**Meeting Date:** Tuesday 16 April 2013  
**Location:** Committee Room 2, Level 5, Civic Centre, 1 Devlin Street, Ryde  
**Time:** 5.00pm

Item	Page
1 CONFIRMATION OF MINUTES - Meeting held on 2 April 2013.....	1
2 22 MONS AVENUE, WEST RYDE. LOT 23, Section C, DP 2322. Local Development Application for demolition, construction of a residential flat building with six (6) apartments and basement car parking for eight (8) cars. LDA2012/0454. <i>INTERVIEW 5.00PM</i> .....	4
3 93-95 VIMIERA ROAD, EASTWOOD. LOT 9 SP 68723. Section 96 application to delete condition of consent requiring compliance with (former) State Environmental Planning Policy No 5 - Housing for Older People or People with Disabilities. MOD2012/122. ....	104
4 66A PELLISIER ROAD, PUTNEY. LOT B DP 419543. Local Development Application for new dual occupancy. LDA2012/0106. <i>INTERVIEW 5.10PM</i> .....	126

**1 CONFIRMATION OF MINUTES - Meeting held on 2 April 2013**

**Amended Plan – received 19 February 2013 (and notified to objectors)**

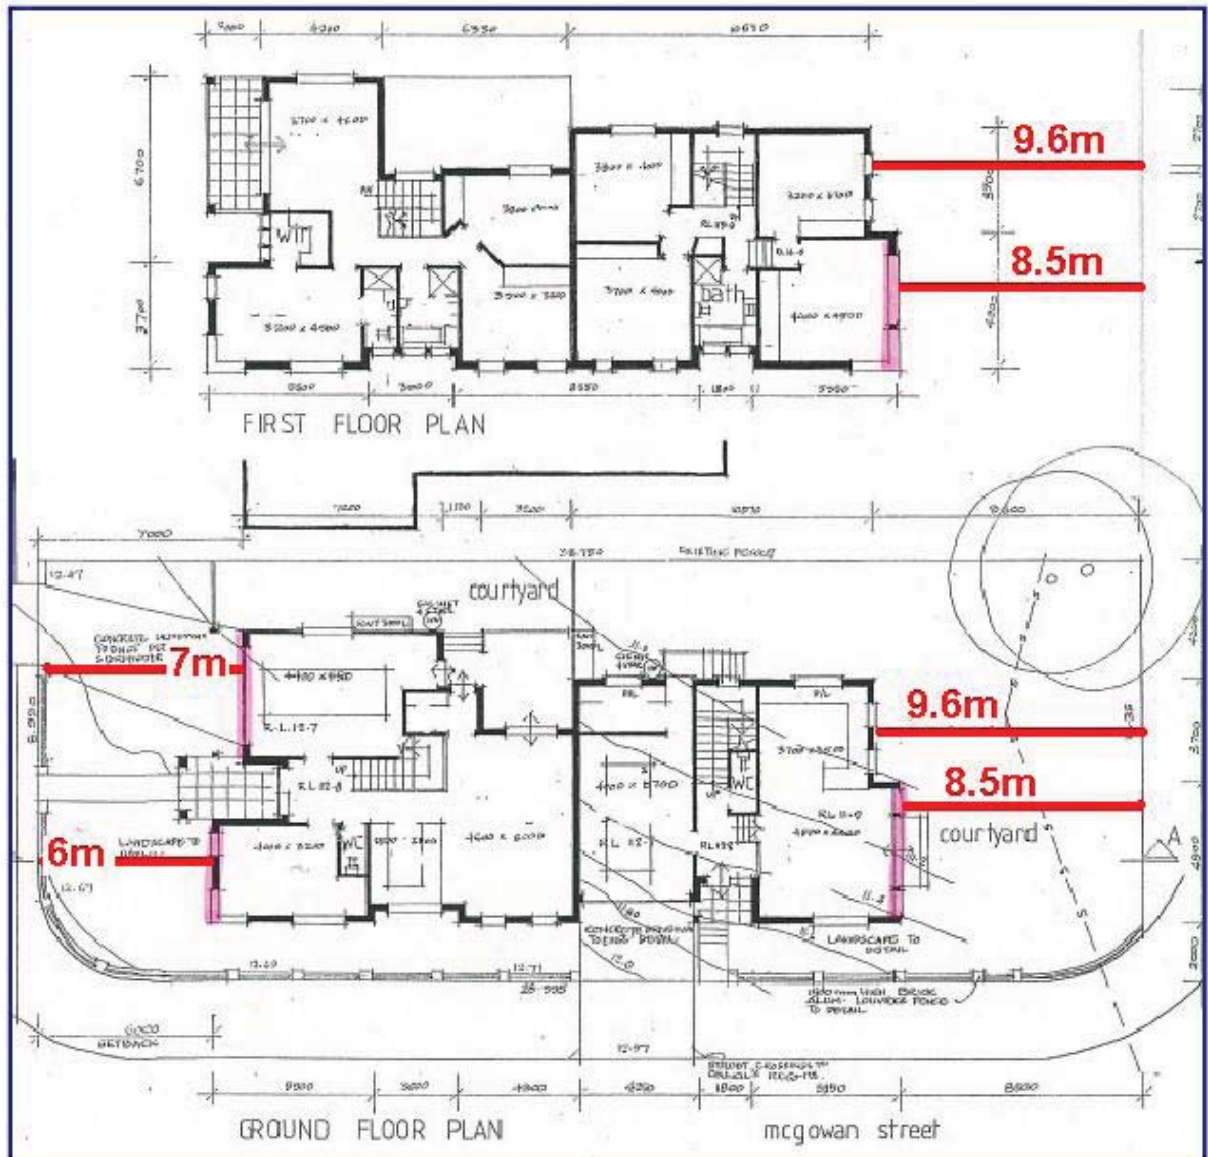
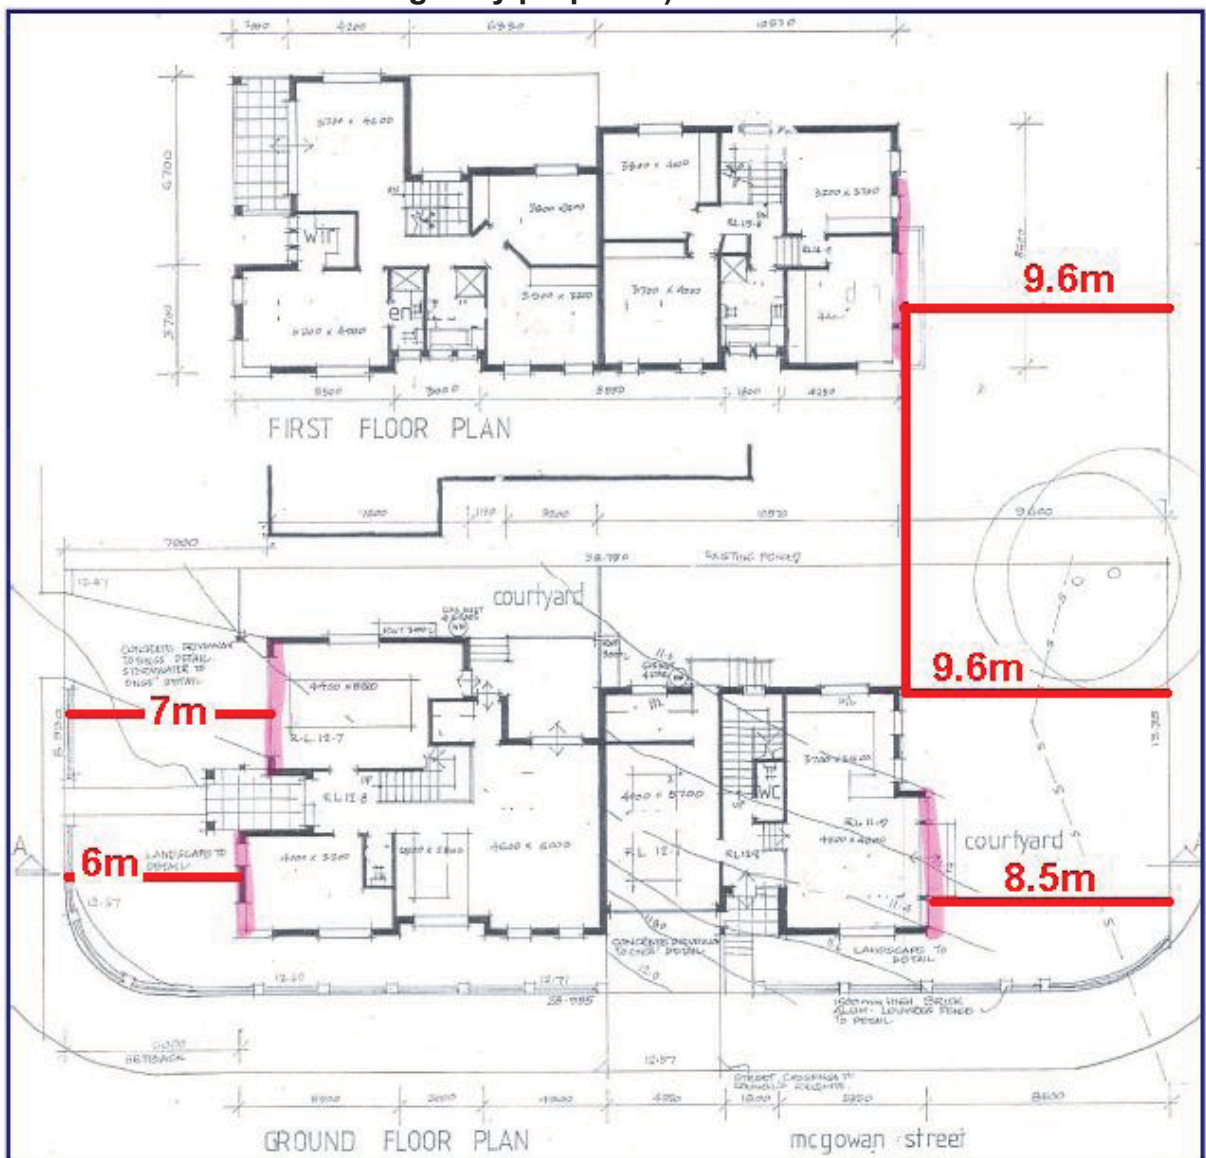
Increased rear setback on the ground floor from 6.8m to 8.5m, 1<sup>st</sup> floor setback amended to between 8.5m to 9.6m and garage now behind building line.

After notification of the amended plans, the residents at 68 Pellisier Road strongly objected to the decrease in the 1<sup>st</sup> rear setback from 9.6m to 8.5m stating that this was never agreed to in the mediation meeting and the 1<sup>st</sup> floor setback was to remain fully compliant.

It would appear that there was a misunderstanding by the applicant as to what was allowed. The applicant advised that they were under the impression that due to the lost of floor space on the ground floor, the 1<sup>st</sup> floor setback can be amended to be in line with the agreed setback of 8.5m.

The applicant was advised that this was not the case. The decrease in the 1<sup>st</sup> floor setback was not agreed to as the 1<sup>st</sup> floor setback was fully compliant. Accordingly, the applicant has amended the plans (dated 18 March 2013) to increase the 1<sup>st</sup> floor setback to 9.6m as originally proposed, as shown below.
